# Z-90

**APPLICANT:** David Pearson Communities, Inc.

**PETITION NO.:** Z-90

**ZONING COMMENTS:**

Z-90  
(2015)

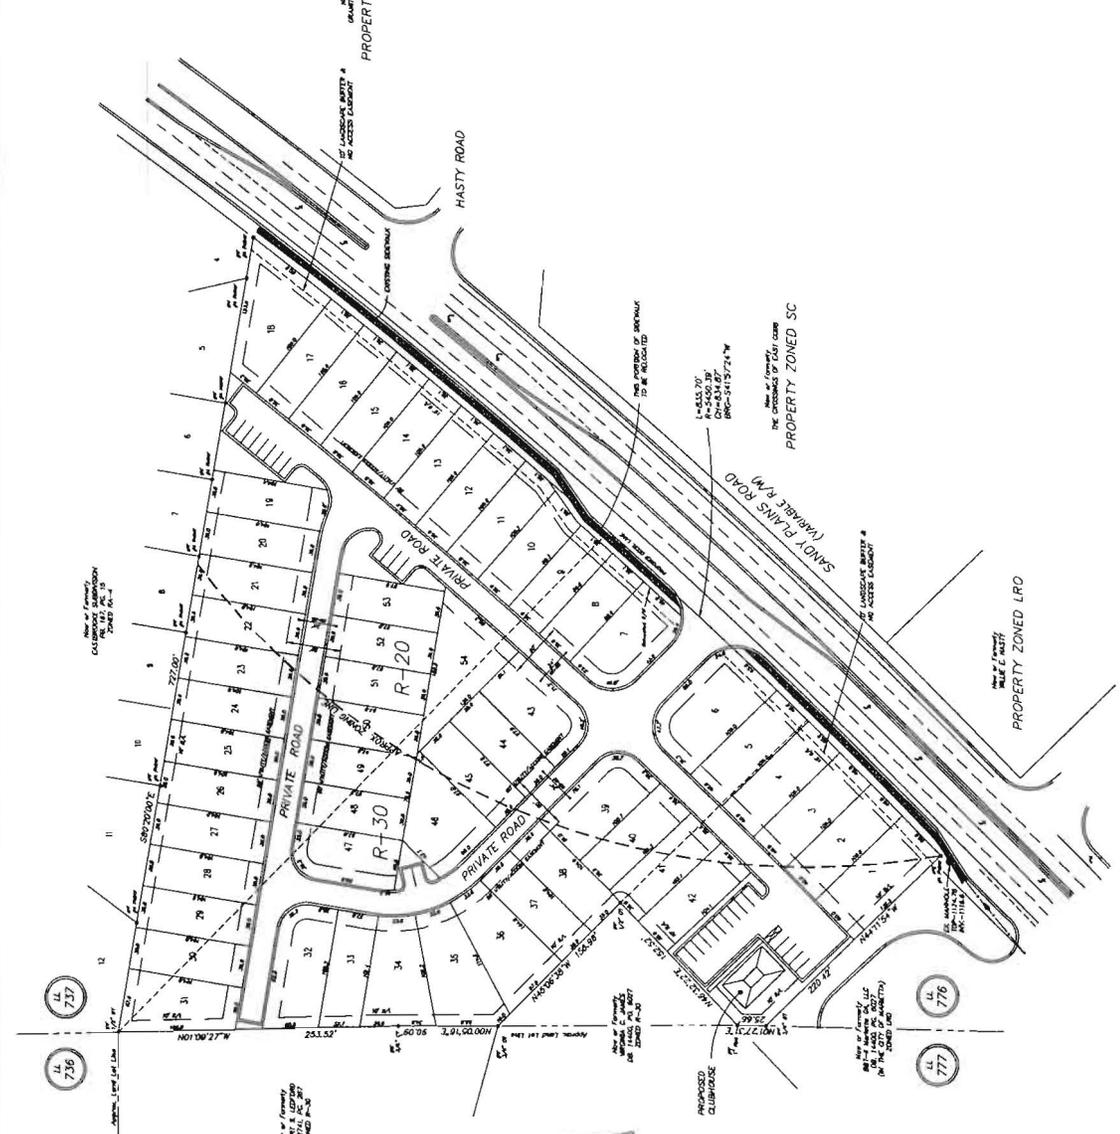
INSUFFICIENT INFORMATION

- No Stormwater controls shown \_\_\_\_\_
- Copy of survey is not current – Additional comments may be forthcoming when current site conditions are exposed.
- No site improvements showing on exhibit.

1. The majority of the site drains to the west through existing residential parcels. There does not appear to be any well-defined conveyance through these parcels or any existing culvert under Ross Road. This issue will need to be addressed at Plan Review. The northeast corner of the site (approximately 1.3 acres) drains to the Sandy Plains Road Right-of-Way.
2. The developer is proposing the use of private roads which will require that all stormwater infrastructure be private as well and maintained by a mandatory home-owners association.
